DOCKETED	
Docket Number:	23-OPT-01
Project Title:	Fountain Wind Project
TN #:	255883
Document Title:	fwp_wildfire_response_to_ROCs_memo
Description:	N/A
Filer:	Caitlin Barns
Organization:	Stantec Consulting Services, Inc.
Submitter Role:	Applicant Consultant
Submission Date:	4/23/2024 8:52:33 AM
Docketed Date:	4/23/2024

Reference: Fountain Wind Project Wildfire Supplemental Information and Response to CAL FIRE Records of Conversation

Figure No. 1

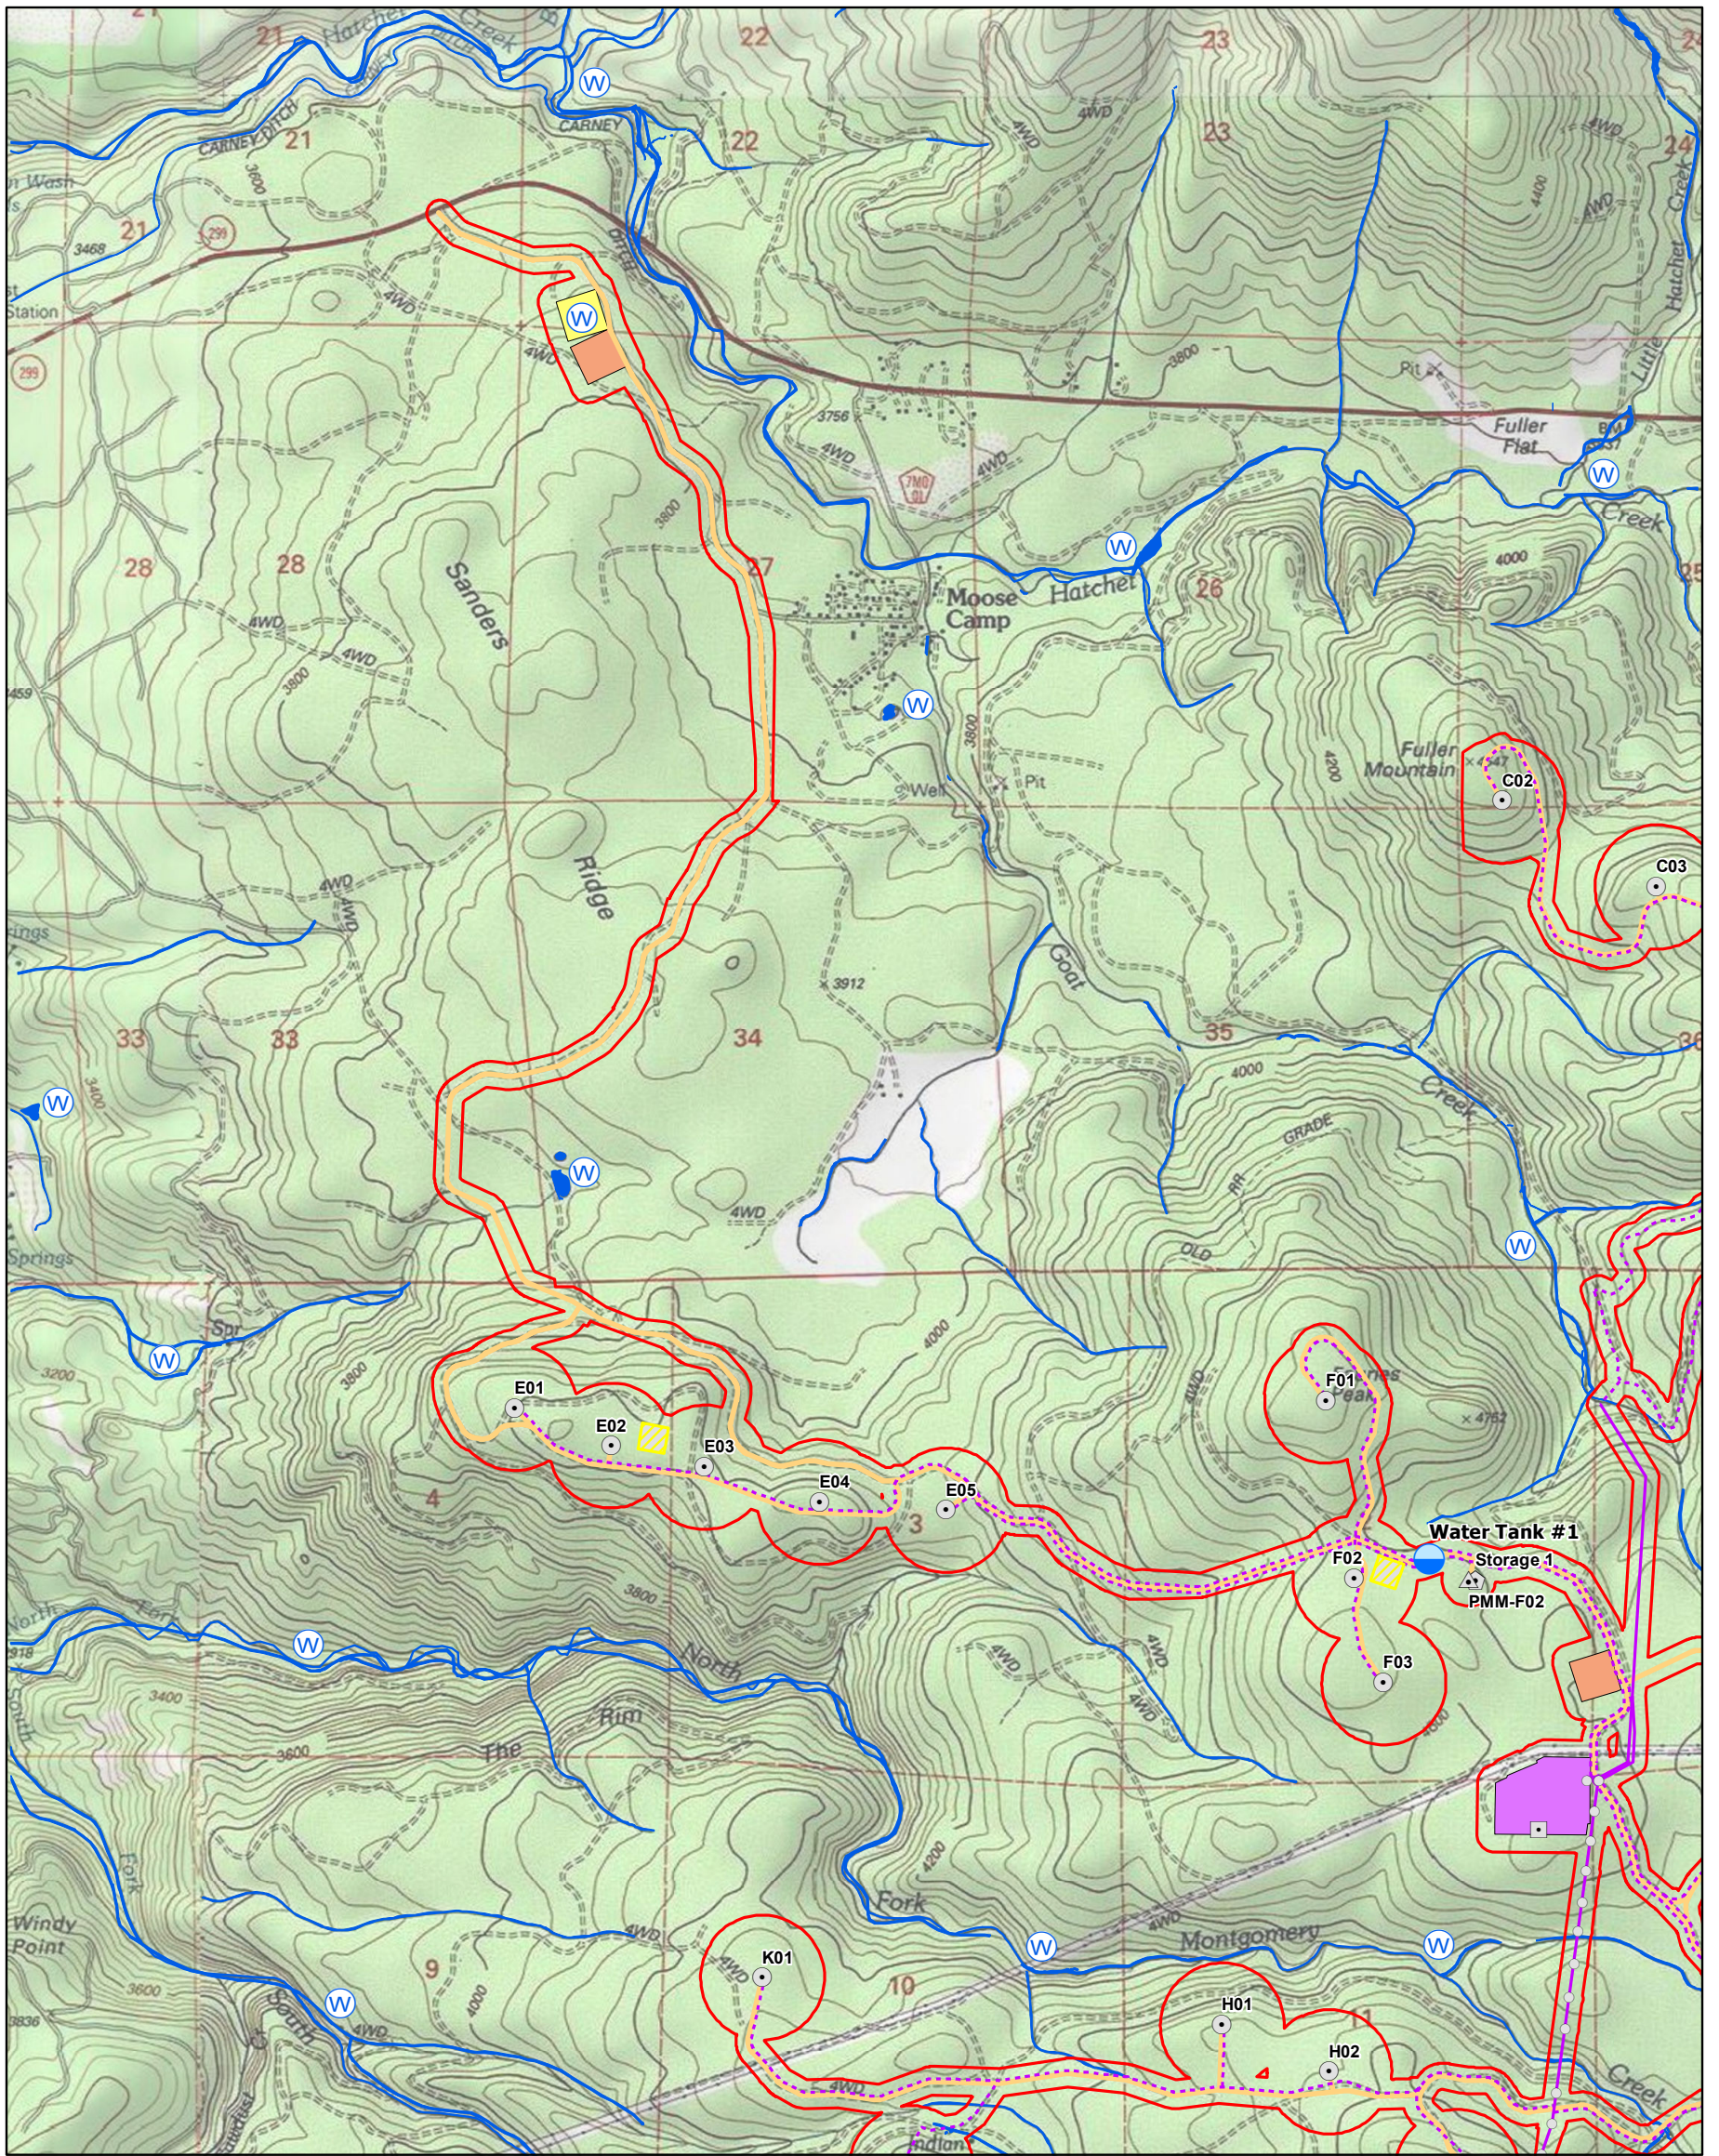
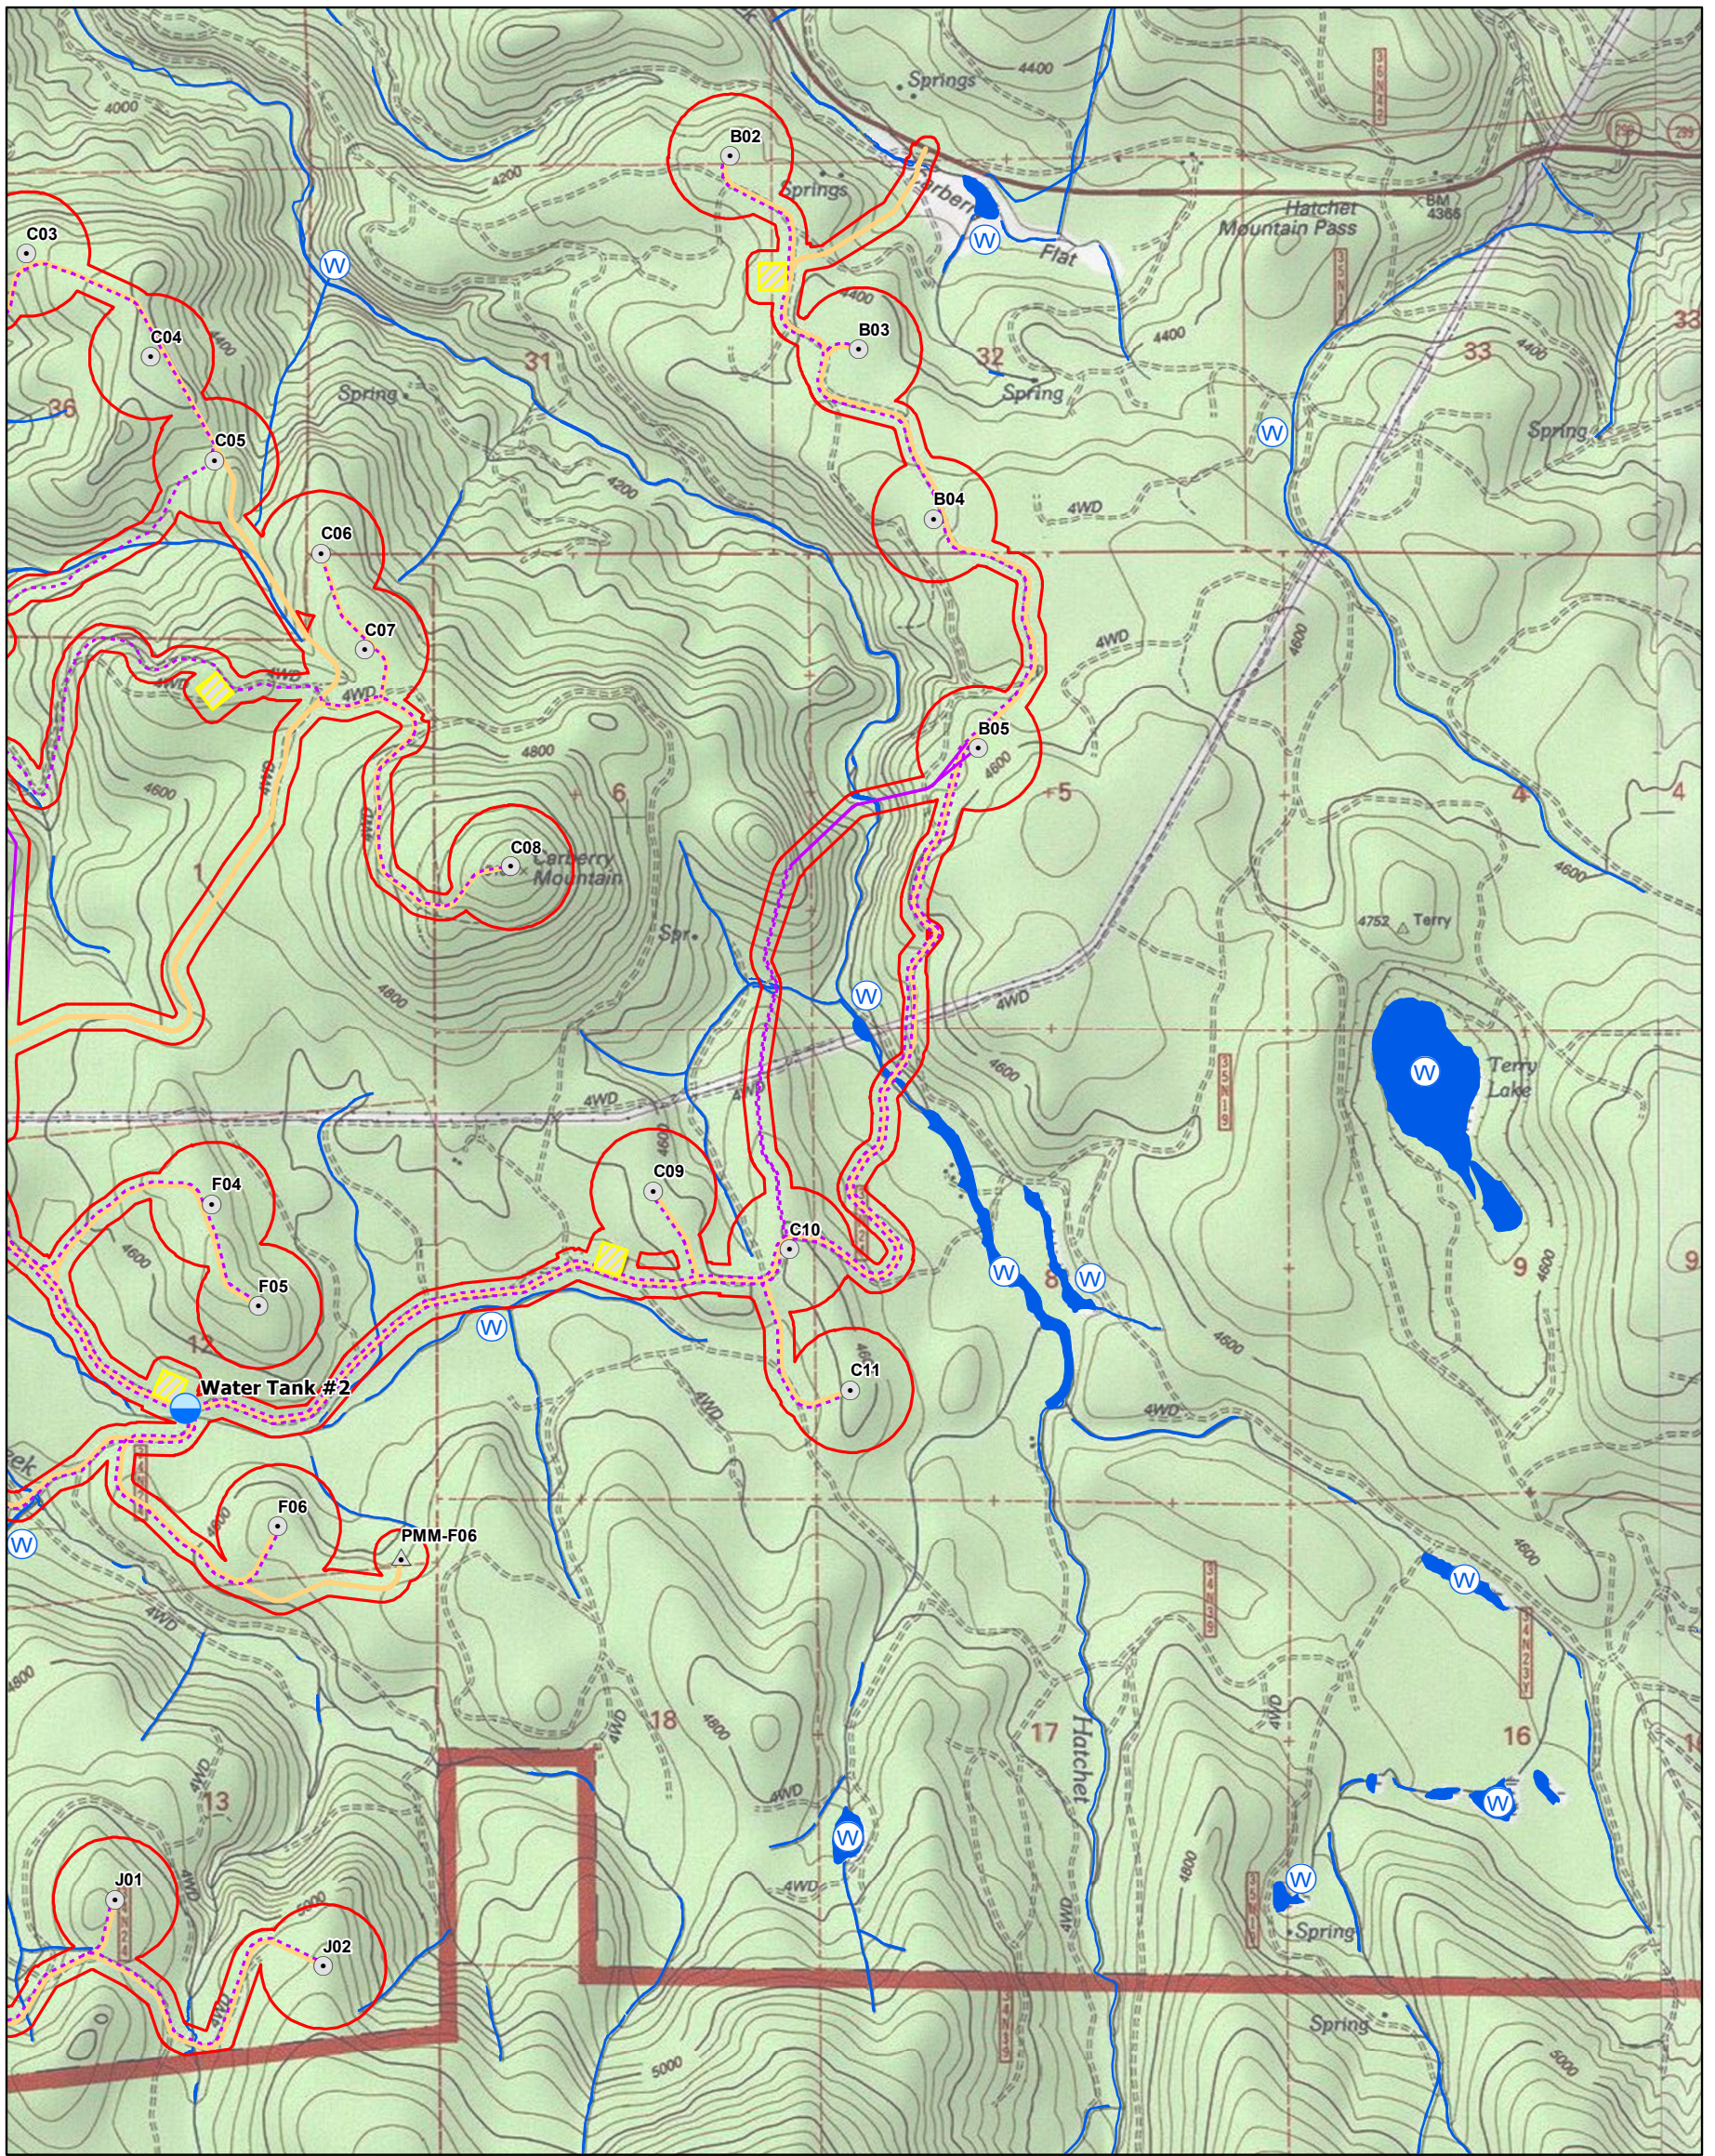
Shasta County Fire Department Answer: CAL FIRE noted that they would likely let the fire burn out and have personnel onsite to monitor it and put out any incidental fires triggered by embers. CAL FIRE noted that the planned onsite water tanks would not be very useful in firefighting as they would need to be refilled for continuous use, that there is no water supply in the area, and that a hydrant system would be more useful.

Shasta County Fire Department Answer: No. The 5000-gallon tanks would only provide a few fill ups of the average fire engine tank which holds 500-1000 gallons. If no other sources of water are available onsite it would need to be trucked in by water tender trucks with average volumes of 3500 gallons or drafted from a local water source/feature. The Chief indicated that if the tanks are gravity fed then they are not adequate for firefighting use. He would prefer to see a hydrant system installed on the project site and has discussed and requested this during a meeting with the Applicant. The required adequate fire flow for the buildings would be calculated by Shasta County Fire for final building design and permitting.

available for future firefighting use. Third, water for firefighting would be available from the new well and associated storage tank at the Operations and Maintenance facility. Finally, fire fighters commonly draw water for fire suppression from nearby surface waters. Surface water features exist on and near the Project site and could be available to refill engines and water tenders. Nearby water sources are identified on Figure 1.

The CEC is referencing the 10,000-gallon helicopter dip tank that currently exists at the project site. This tank can be used by equipment and apparatus other than helicopters to source water. Up to three new 5,000-gallon tanks, and a water storage tank that would supply the O&M building and be connected to a new well, will also be installed onsite and can be used for ground-based firefighting operations. All onsite tanks and water sources as shown in Figure 1 and 2 will be available for immediate refill during a fire incident response with water tender relay operations, as is standard practice for Shasta County Fire Department. Figure 2 shows locations of nearby perennial surface waters also available for fire response.
